RECORD OF DECISION MODIFICATION
YAK TUNNEL OPERABLE UNIT
CALIFORNIA GULCH SITE, LEADVILLE, COLORADO

This document sets forth changes in the Declaration and Decision Summary for the Record of Decision (ROD) for the Yak Tunnel Operable Unit of the California Gulch Site signed on March 29, 1988.

FIGURE A.7
NORMAL FLOW, RESURRECTION AND
IBEX PLUGS WITH PORTAL PLUG DRAINING
BLACK CLOUD PUMPING

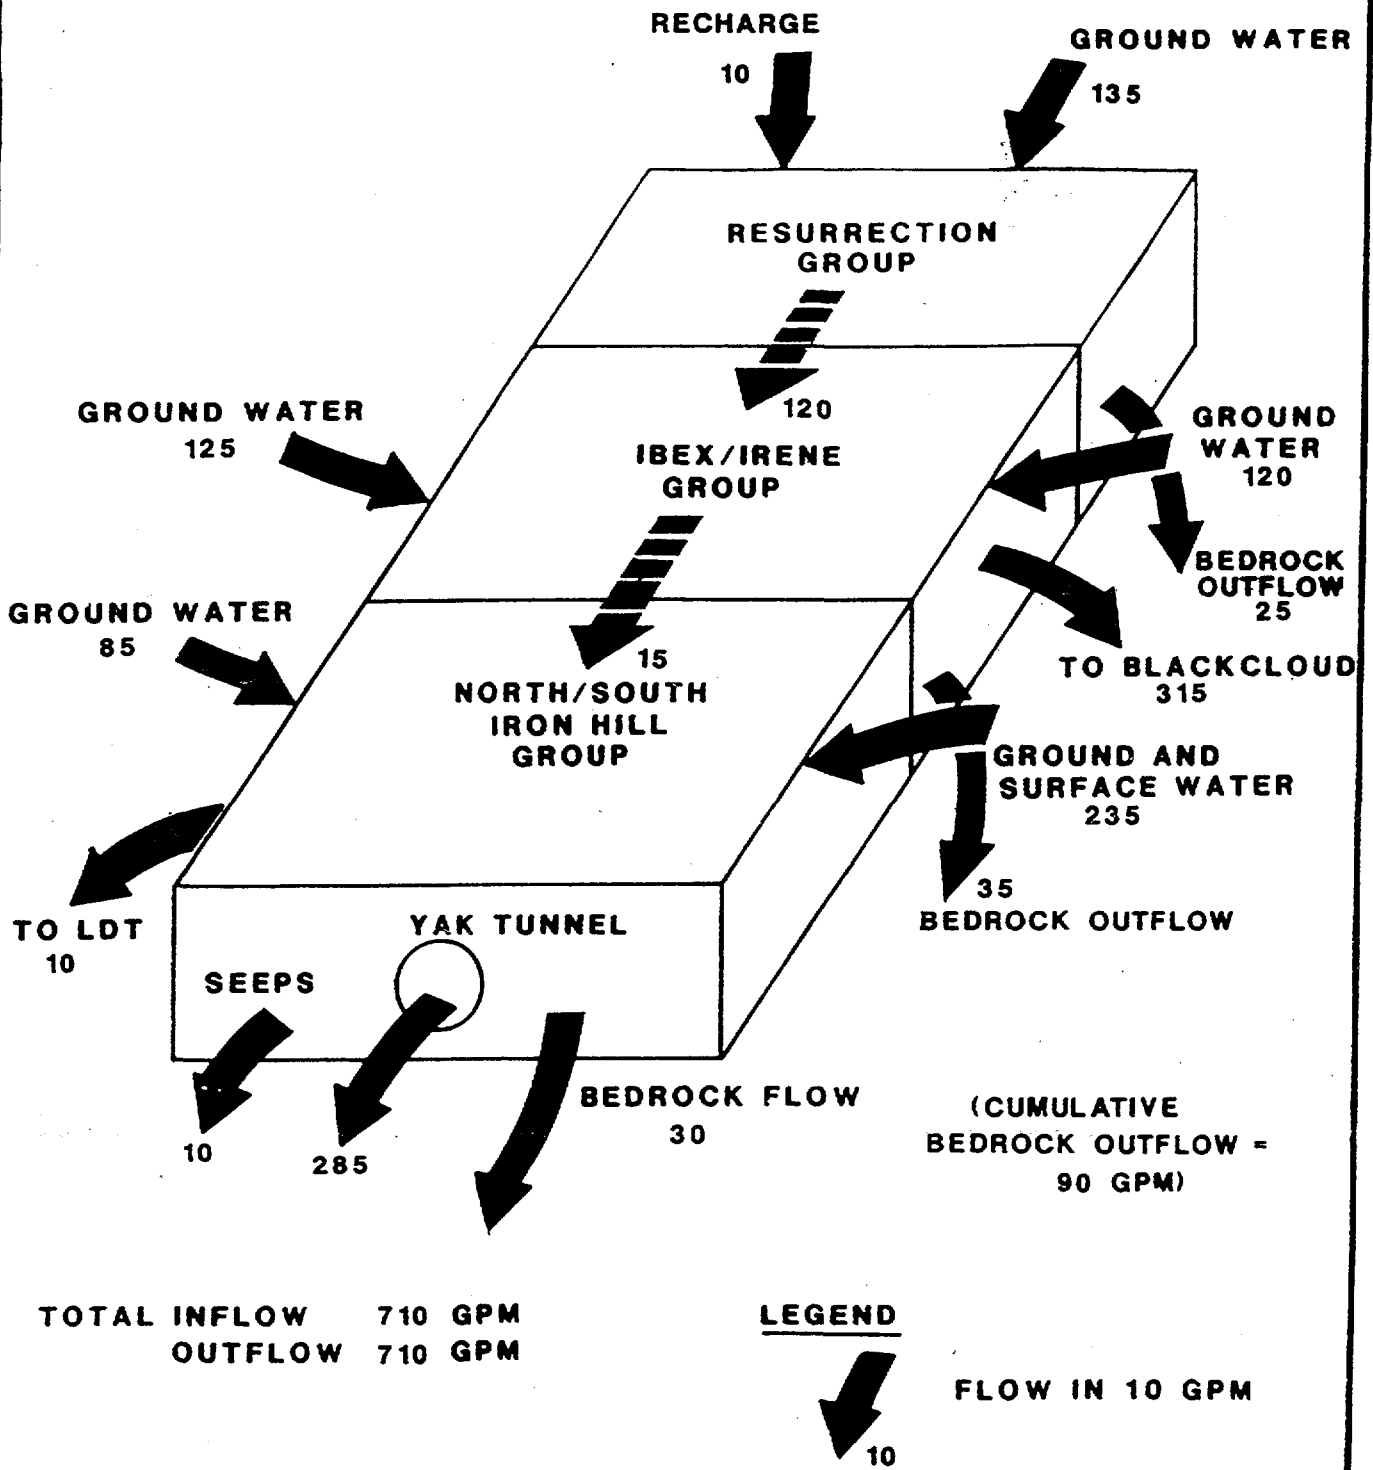
2. Figures A.7 and A.8 have been modified to reflect the modified remedy. Substitute the attached figures.

After installation of the Resurrection and Ibex plugs and the portal flow-through plug, the Yak Tunnel portal flow will be reduced to about 285 gpm (Figure A.7). The proposed location of the plugs is shown in Figure A.4. Water levels in the Resurrection and Ibex Groups would increase to approximately 10,750 feet and 10,650 feet mean sea level (msl), respectively. Sulfide rock would still be present above the water table and some acidic mine drainage formation would persist. Deep ground water flow would total approximately 90 gpm and inflow to Black Cloud would be about 315 gpm. Ground water seepage toward the Leadville Drainage Tunnel and local seeps would be about 10 gpm each.

FIGURE A.8

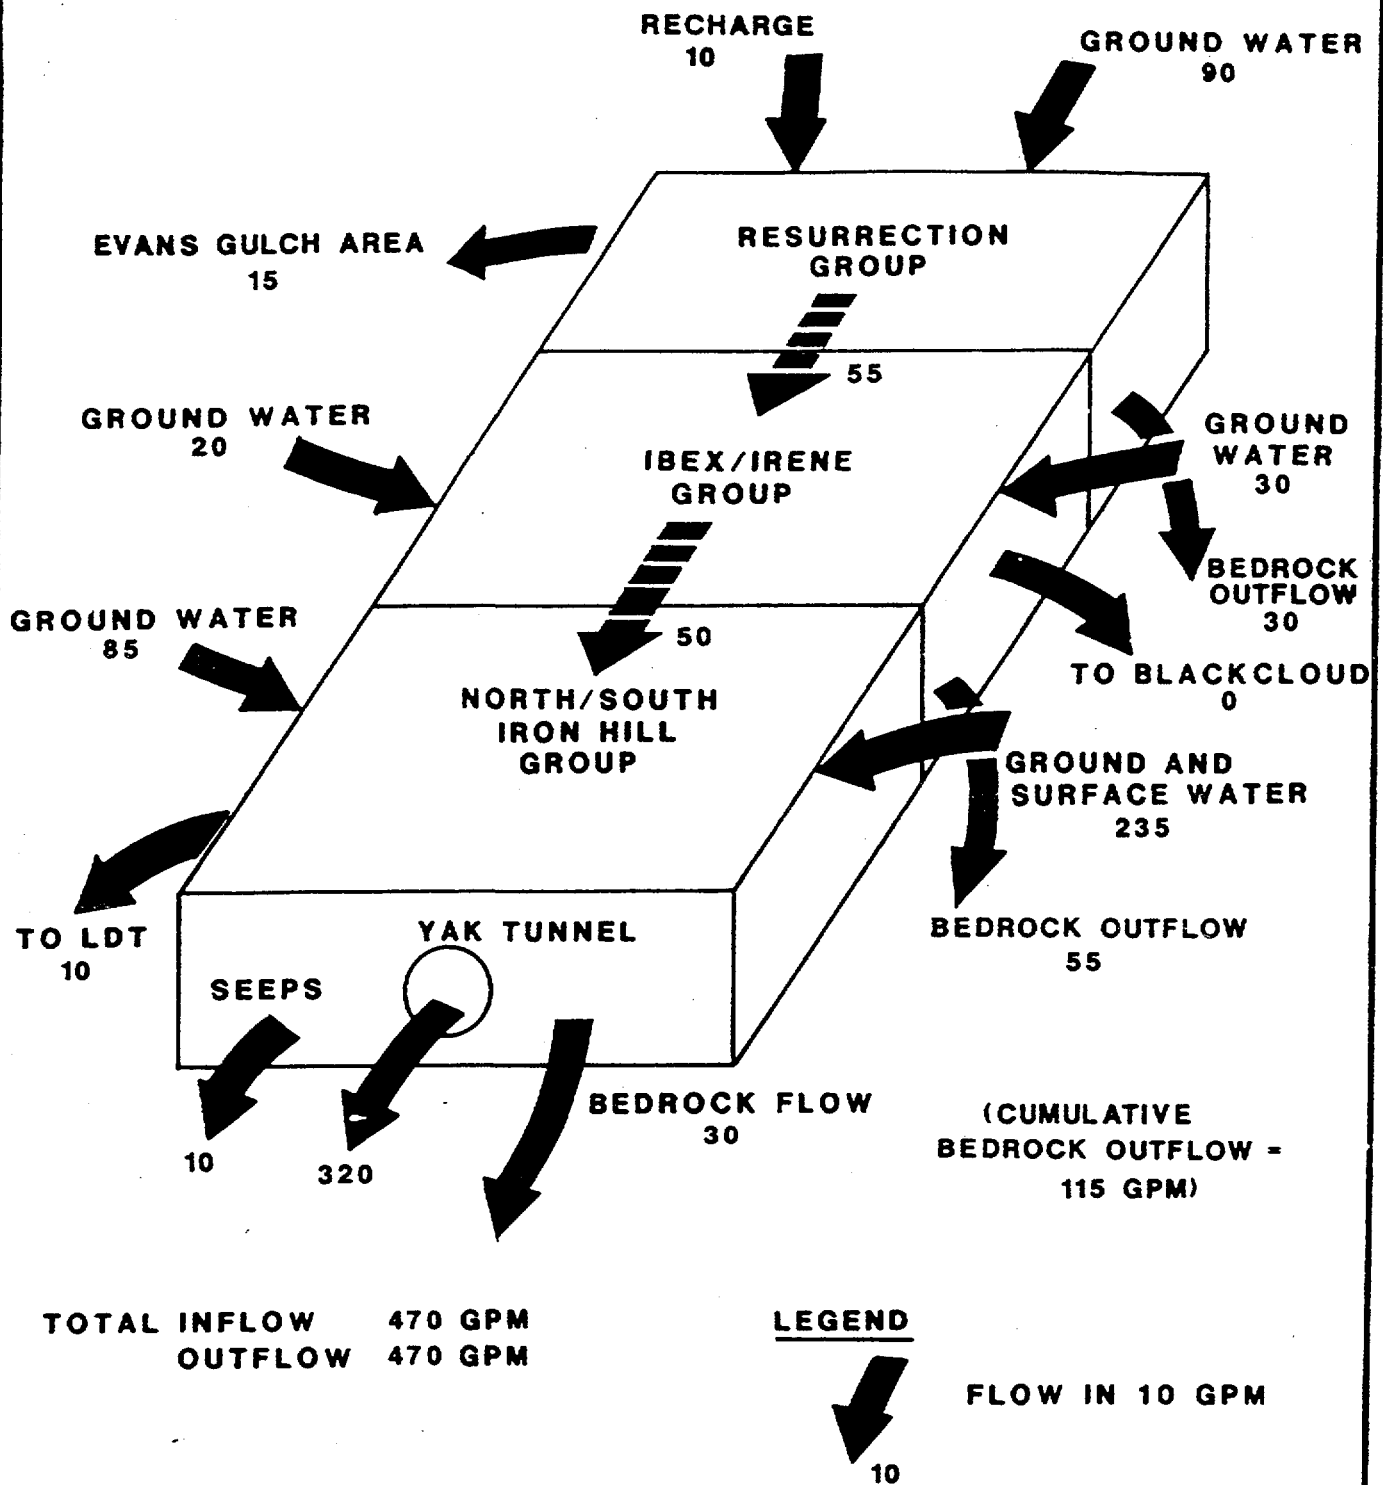
When the Black Cloud mine is not pumping and the Resurrection, Ibex, and portal plugs are in place, the water levels in the Irene Group would increase to approximately 10,800 feet msl, while those in the Resurrection Group would increase to 10,900 feet msl. However, acidic mine drainage would likely still occur in these areas because some sulfide rocks would still be exposed. The water level in the Iron Hill Group would not be affected.

The total deep ground water seepage from all mine workings would increase to about 115 gpm and increase the portal flow to about 320 gpm. No increased surface seepage to California Gulch is anticipated. An additional seepage of roughly 15 gpm from the Resurrection Group toward the Evans Gulch area could occur. Due to its small quantity, this seepage is not expected to cause any significant ground water quality deterioration in the Evans Gulch area. The monitoring network, which shows both ground water flow and quality conditions, will provide information to track this condition.
